HORSHAM DISTRICT COUNCIL CONSULTATION

TO:	Horsham District Council – Planning Dept
LOCATION:	Old Clayton Boarding Kennels Storrington Road Washington West Sussex
DESCRIPTION:	Application for Approval of Details Reserved by Condition 7 (underground services), 12 (finished floor levels), 14 (landscape management plan) and 27 (biodiversity lighting design) to approved application DC/23/0701 (Demolition and erection of a 60-bed care home and 8No. age restricted bungalows with associated works). Approval of details reserved by conditions 9 (foul drainage), 10 (Surface water drainage), 11 (sustainable drainage components) and 22 (sustainable drainage management and maintenance) to approved application DC/23/0701 (Demolition and erection of a 60-bed care home and 8No. bungalows).
REFERENCE:	DISC/25/0051 DISC/25/0076
RECOMMENDATION:	Modification / More information Advice No Objection

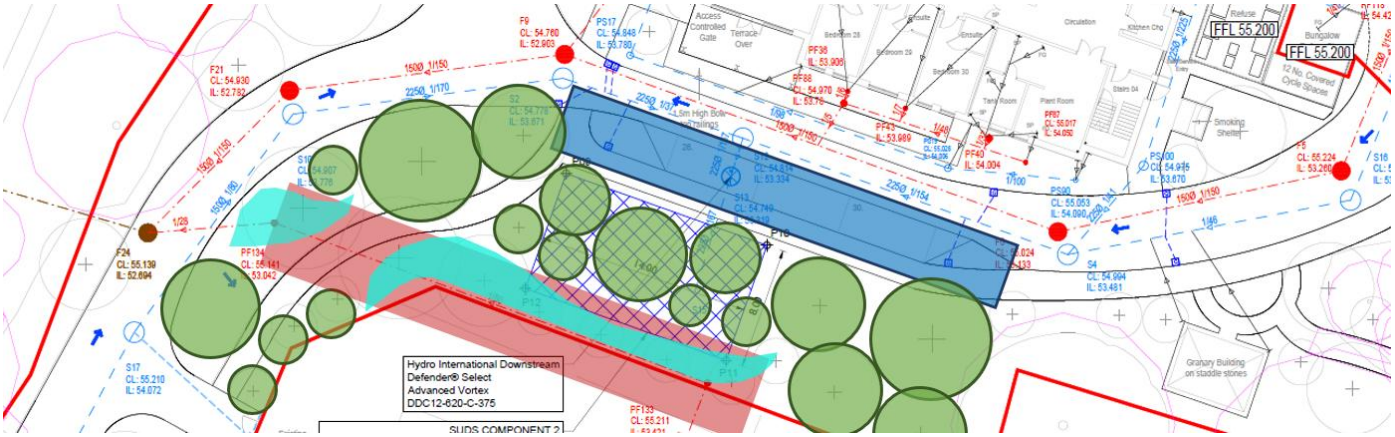
1. Documents reviewed:
    a. External Electrical Layout 2166 HCL ZZ XX DR E 6000 – 08/05/2025
    b. Light Spillage Assessment - 18/04/2023 [approved]
    c. Landscape & Visual Appraisal - April 2023 [approved]
    d. Landscape General Arrangement Plan DD393 – 26/05/2023 [approved]
2. Large discrepancy remains between current proposals [below, right] and Figure 6 of the Light Spillage Assessment under approved DC/23/0701 [below, left].

Given the abutting Dark Night Sky Zone / International Dark Sky Reserve (IDSR), the current external lighting proposals are likely to give rise to adverse landscape and visual effects as a result of increasing levels of light pollution. While we are cognisant that an increased number of luminaires may be required than previously approved, there is no justification for the number currently proposed, therefore we are still unable to recommend the discharge of Conditions 7 & 27 on landscape grounds.

We note response dated 31 July in regard to lighting levels. While this continues to conflict with previously approved plans, we are satisfied with the justification. Closed.
